Version 2 with additional noise report

Easton Estate – A47 Easton to North Tuddenham Road Improvement Scheme

Subject: The A47 North Tuddenham to Easton Development – Deadline Submission Noise

Plan extract showing extended bund and screen
fencing

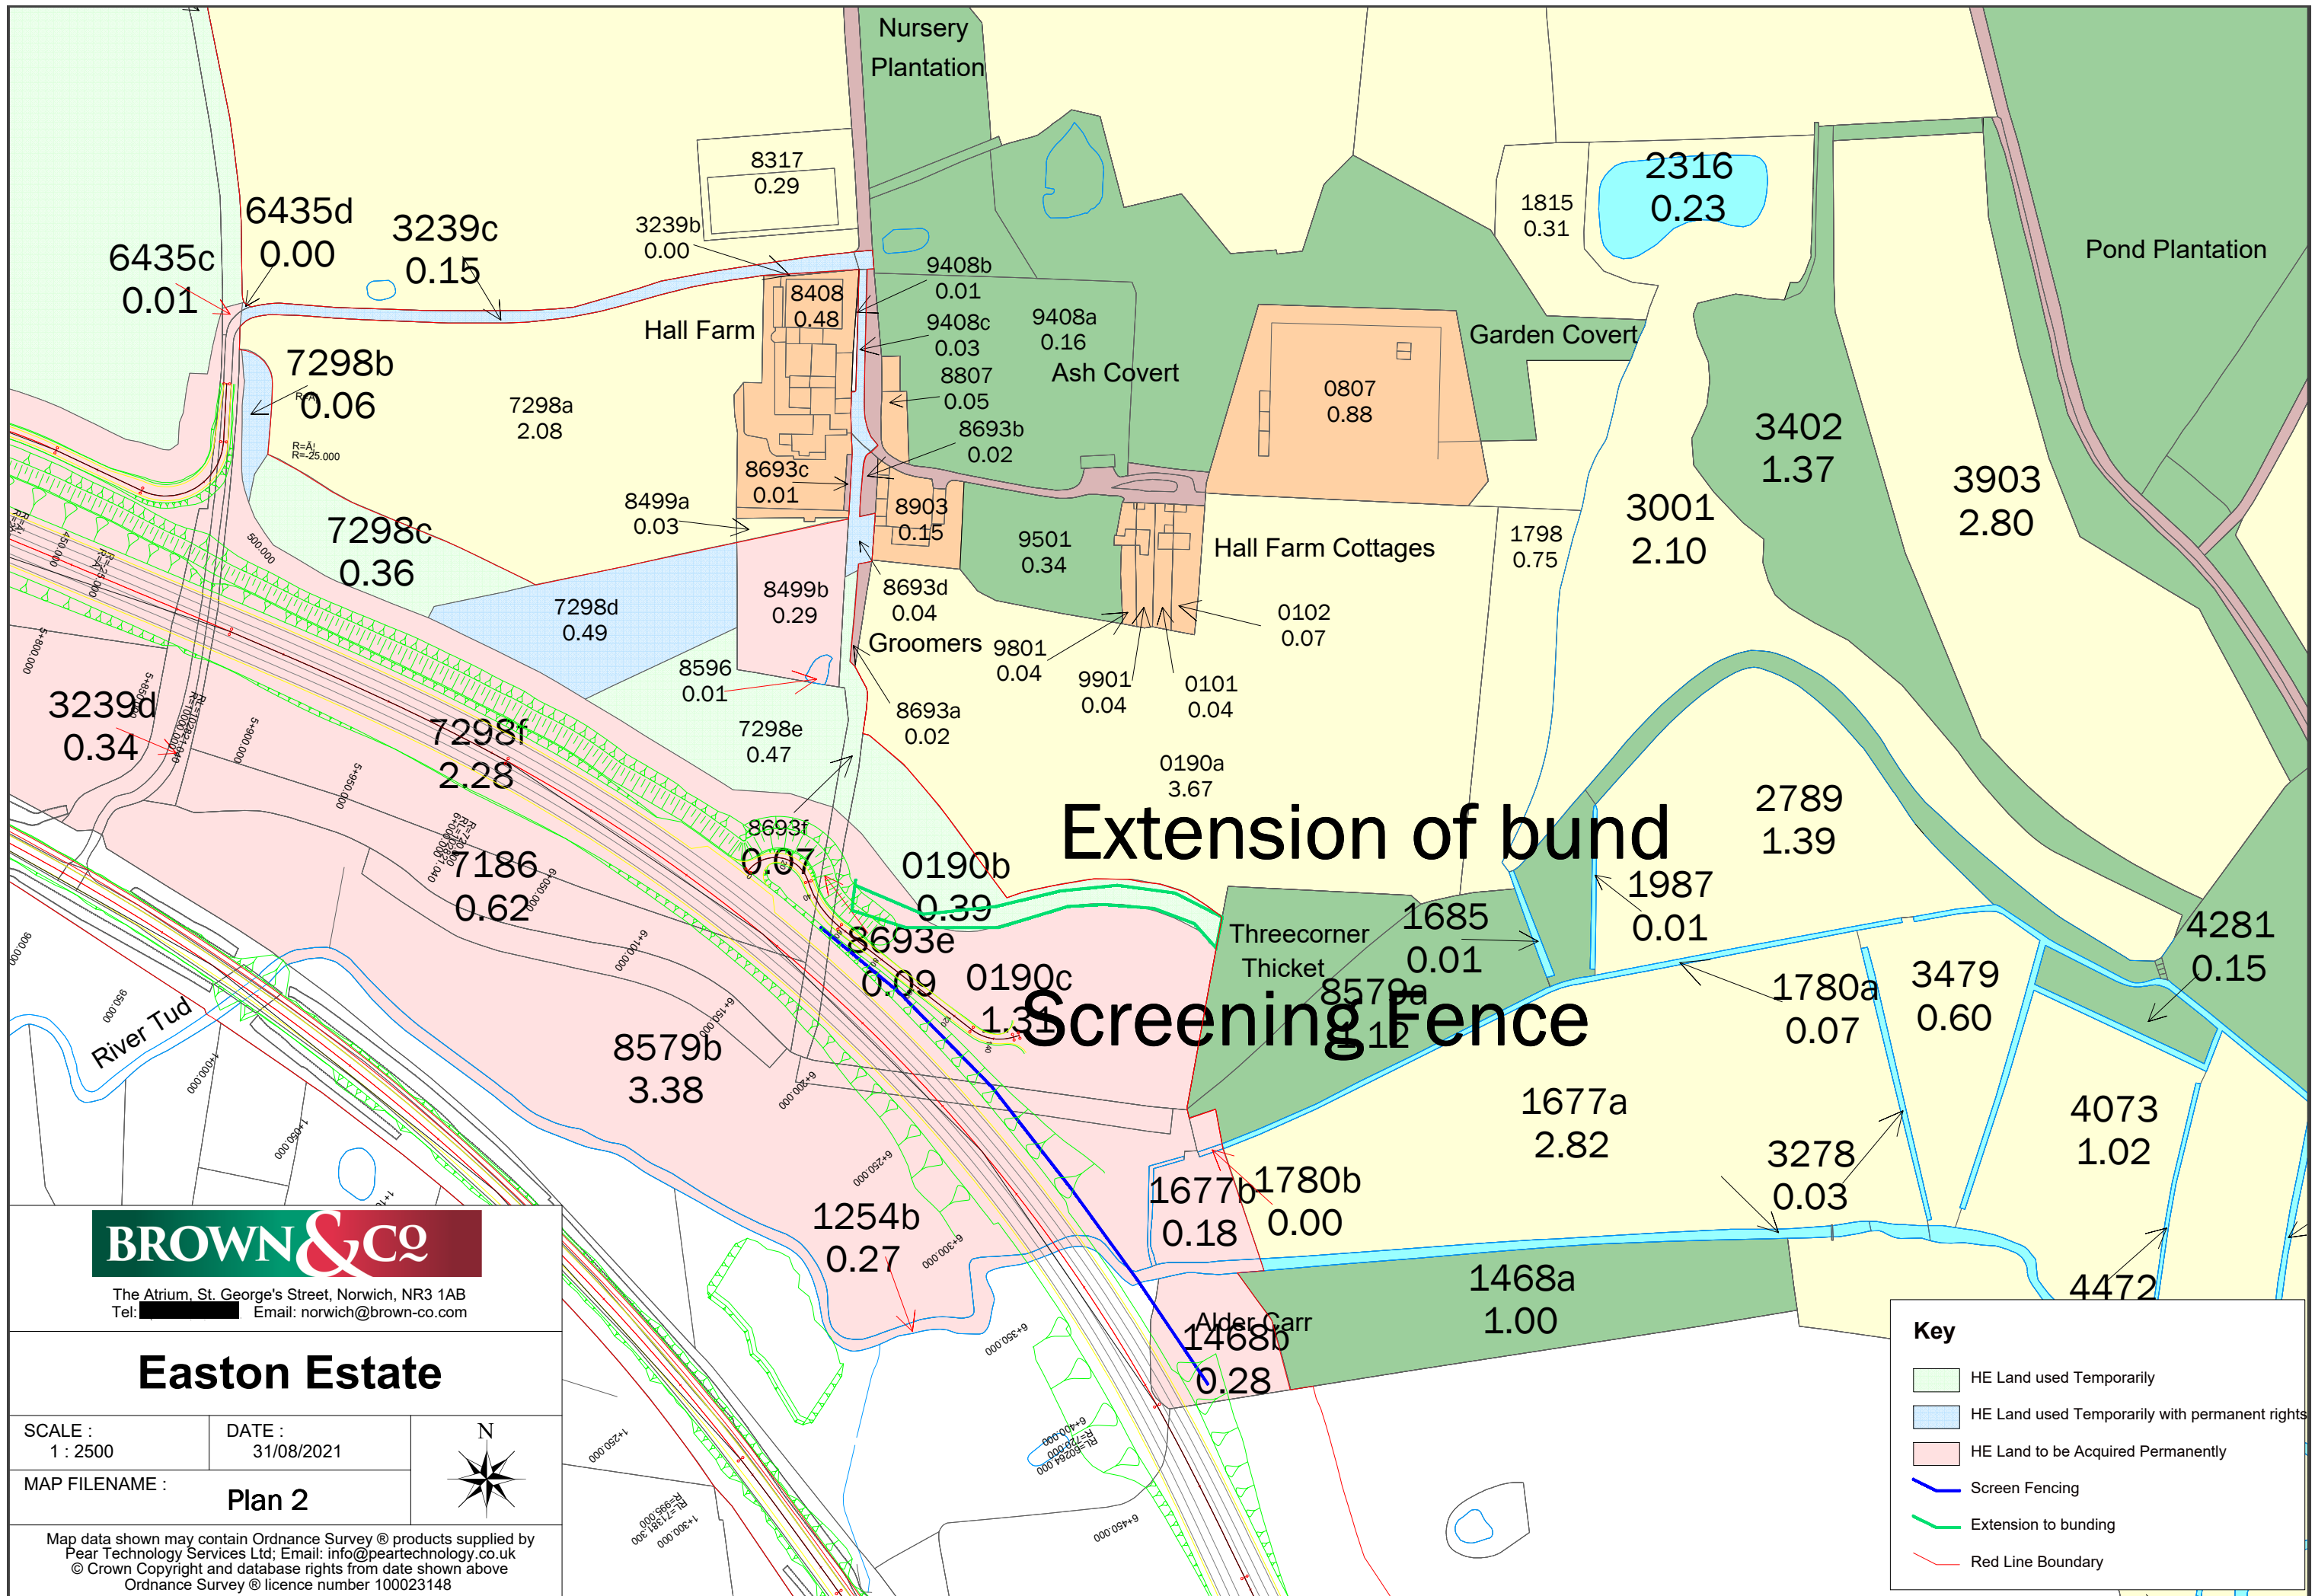
Area 2:

A second area which would benefit the residential properties at Hall Farm significantly is from the edge of the woodland west of Honingham Church, traveling west bound directly on the north side of the works.

This would screen headlights and vehicles before the proposed bank has any impact unless the embankment is made significantly taller.

As mentioned earlier, ideally the embankment would be realigned to the north of the attenuation lagoon near Hall Farm to protect Hall Farmhouse, the buildings and the four cottages.

- iv. Continue the embankment beyond the attenuation lagoon south-east of Hall Farm for protection of the houses.
- v. Including more robust screening between the current Easton roundabout and Taverham Road if the addition of embankments is not possible in this location.

Figure 2: Excerpt of Figure 11.8 From Appendix 6.2 Overlaid With Estate Boundary

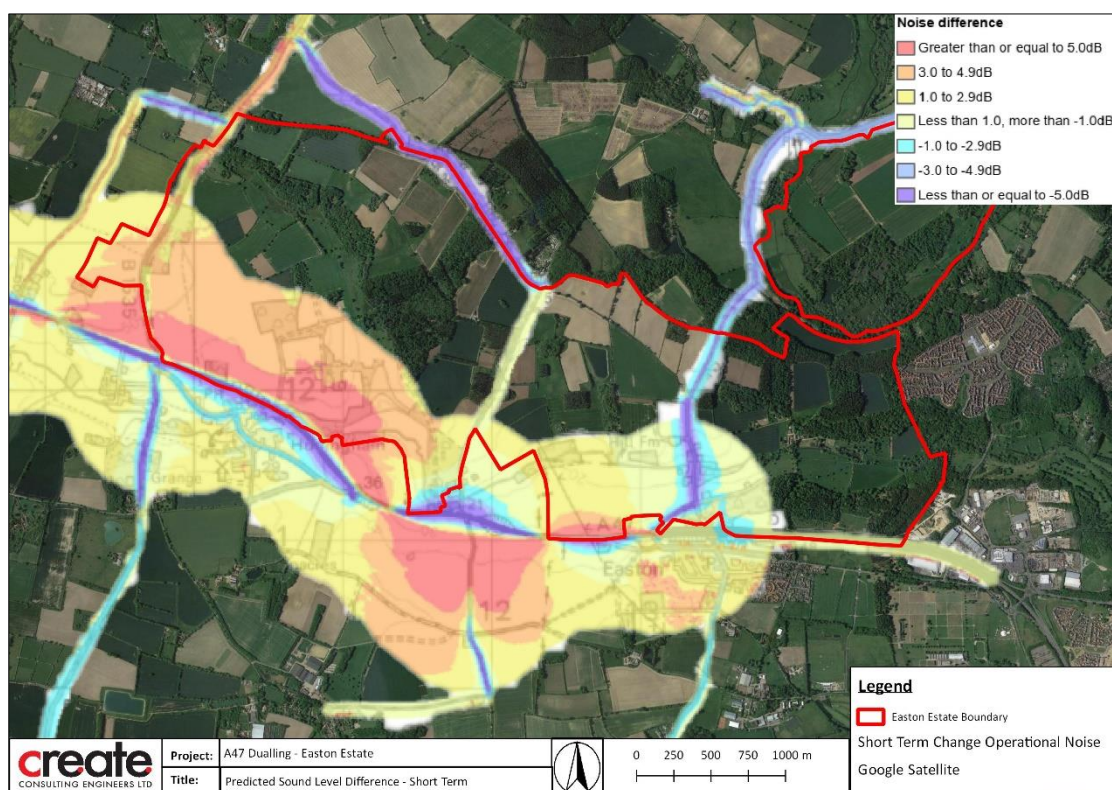
- 2.6 The operational sound levels should be considered against the existing acoustic climate. This is particularly apparent for properties and roads which are away from the main dual carriageway, but would be used as access routes for local traffic or for diversion routes. The noise model prepared by the applicant has shown that these increases in both the short and long term would be significant.
- 2.7 We have overlaid the short-term noise difference contour for the proposed scheme onto an aerial image of the estate to illustrate how the increase in sound levels will impact upon a large degree of the estate.

- 2.8 Although the majority of the site has been shown to be “Minor or Negligible” it is important to highlight that the calculation area has been restricted to that shown in Figure 2. The proposed usage of Wood Lane would increase the sound levels dramatically for the properties along this route which have been constructed in close proximity to the roadside.
- 2.9 The proposed mitigation does not appear to include any mitigation for this estate, other than low noise road surfacing. The general topography of the site would suggest that the more typical earth bunds and / or acoustic barriers may prove problematic to install, however there are suitable alternative options available to the applicant, other than the “blanket use “ of the Code of Construction Practice (CoCP) and Best Practicable Means (BPM). This is inherently

Figure 3: Predicted (Unmitigated) Construction Sound Levels for Stages 51 through to 65

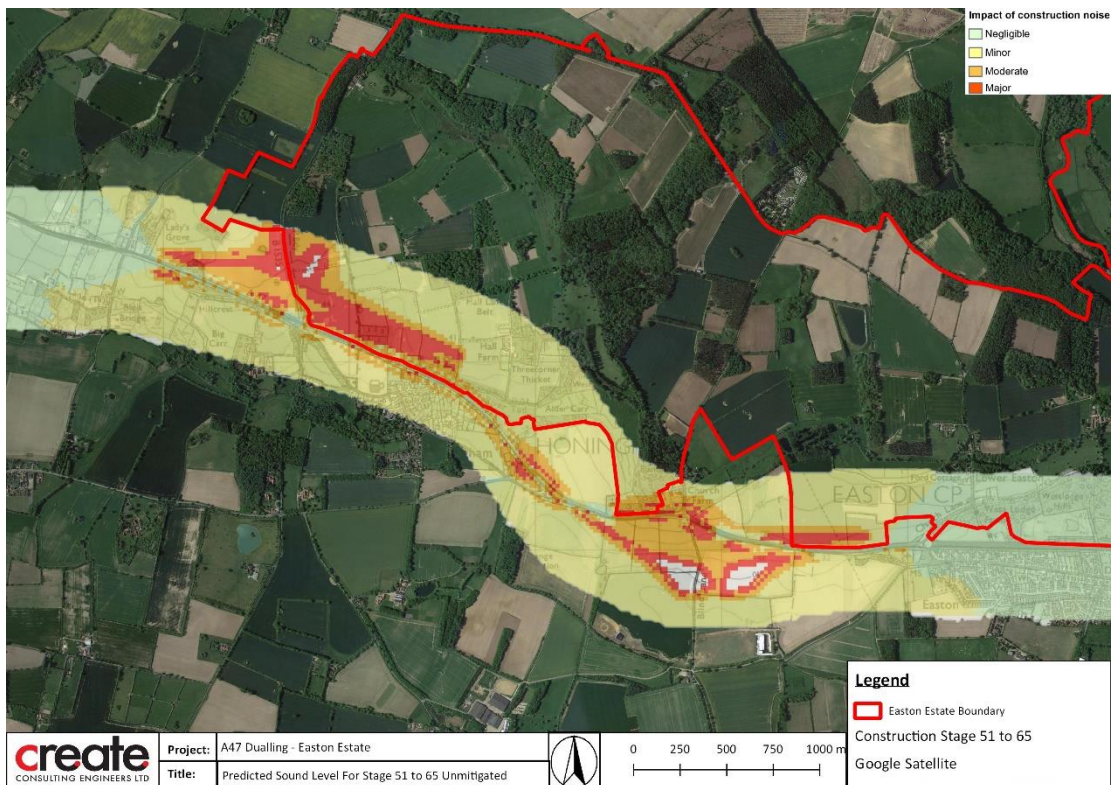
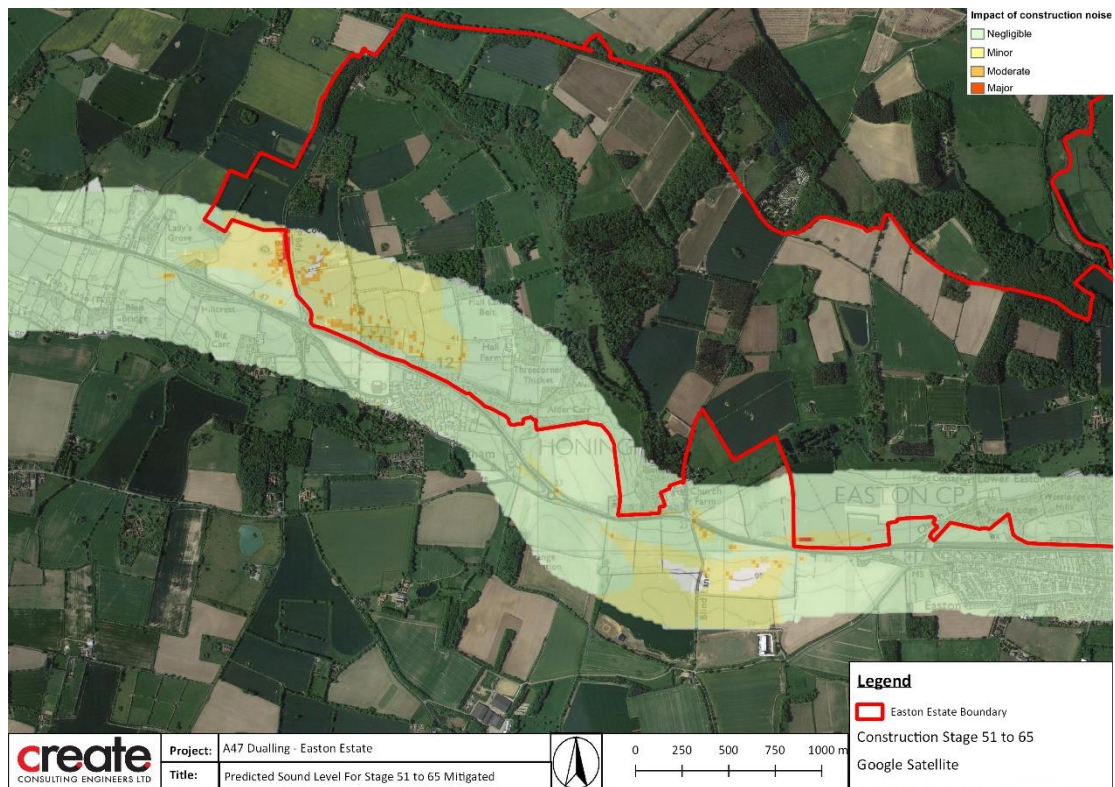
- 2.10 As can be seen in Figure 3, the proposed construction noise levels during the daytime along the southern boundary of the estate would clearly be audible and considered to be Moderate and Major in some locations. It must be noted that these levels are unmitigated. The mitigated sound levels have been shown in Figure 4.

- 2.11 Although Figure 4 shows a significant level of reduction, we are concerned as to the realistic reductions that have been modelled, primarily because the applicant appears to have relied upon the successful implementation and following of the CoCP and BPM techniques. These mitigative strategies have also been based on the assumed construction activities and would need to be recalculated once definitive method statements and RAMS have been prepared.

Figure 5: Predicted (Unmitigated) Construction Sound Levels for Stages 66 through to 69 During Night-time

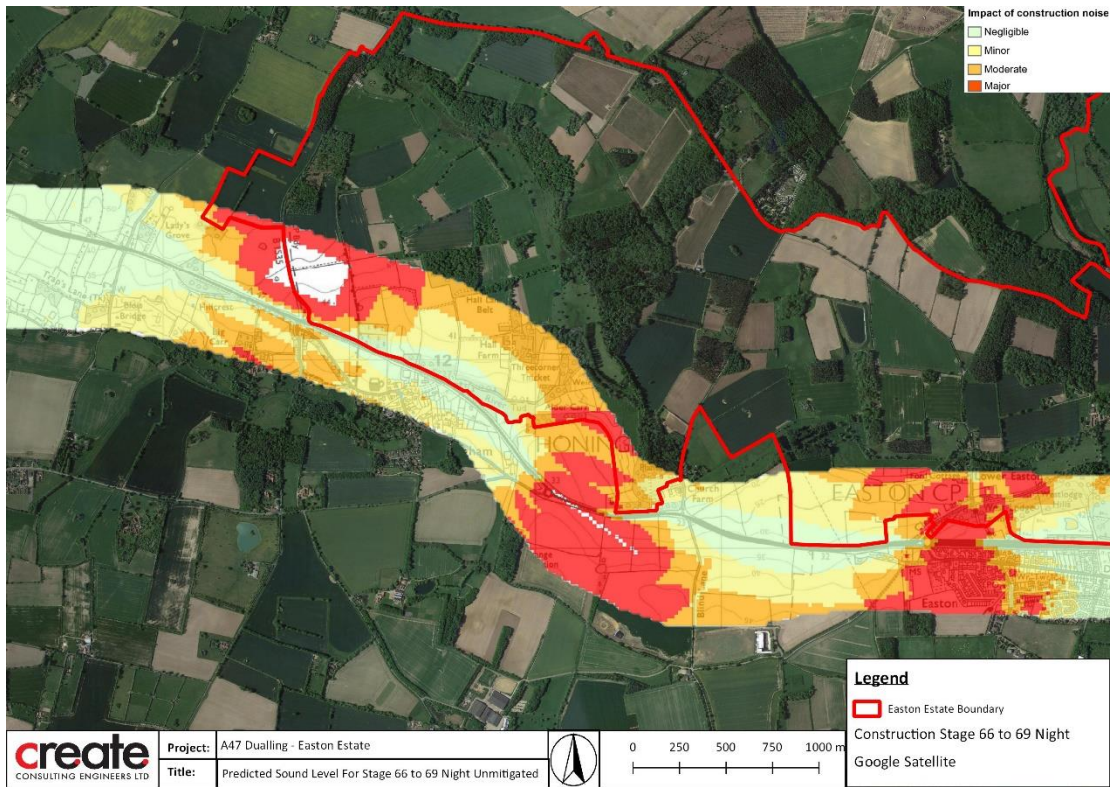
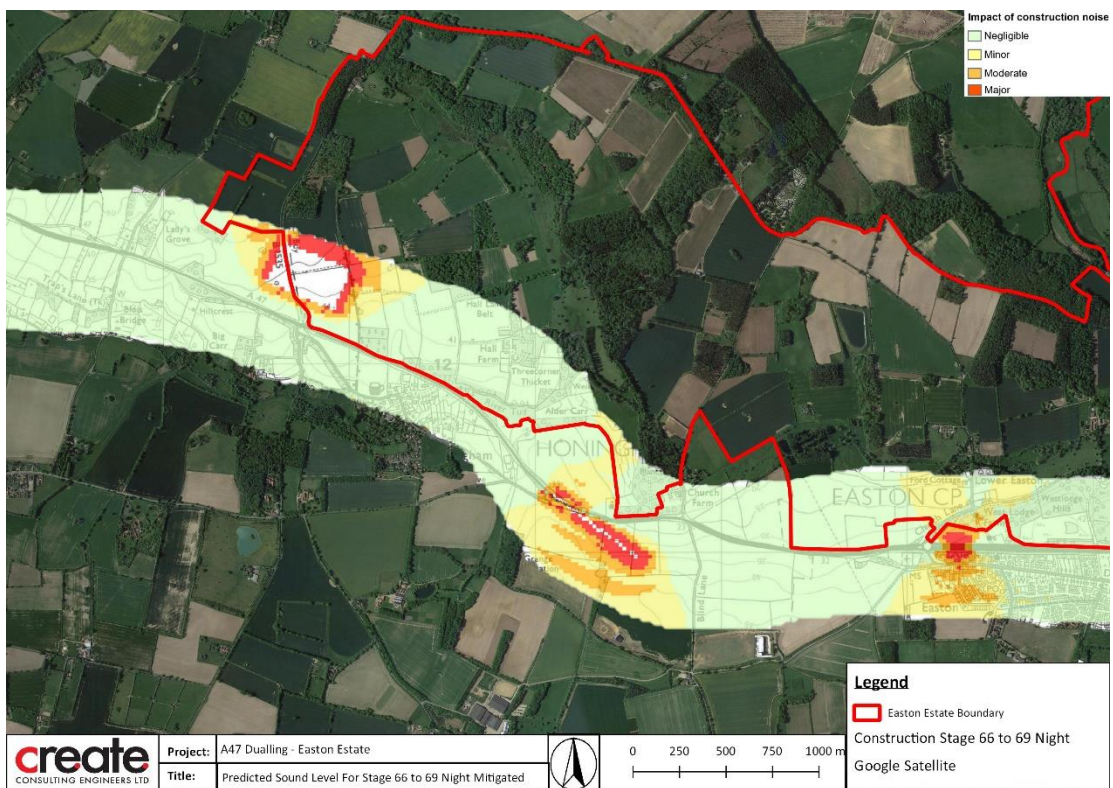
- 2.13 The night-time construction levels have been overlaid in the same manner as previous within Figures 5 and 6. Figure 5 shows the predicted sound level from stages 66 through to 69 during the night-time without mitigation and Figure 6 includes the same but once mitigated.

- 2.14 The night-time construction levels have been predicted to be considered to be Moderate and Major along the key areas at the southern aspect of the estate. Through the reliance on the CoCP and BPM, we have severe concerns that the sound levels would still be classed as being at significantly high levels.

- 2.15 We are seeking a full and conclusive construction noise and vibration assessment be completed once the method statements have been finalised and suitable noise mitigation be implemented to reduce the impact of the construction noise.
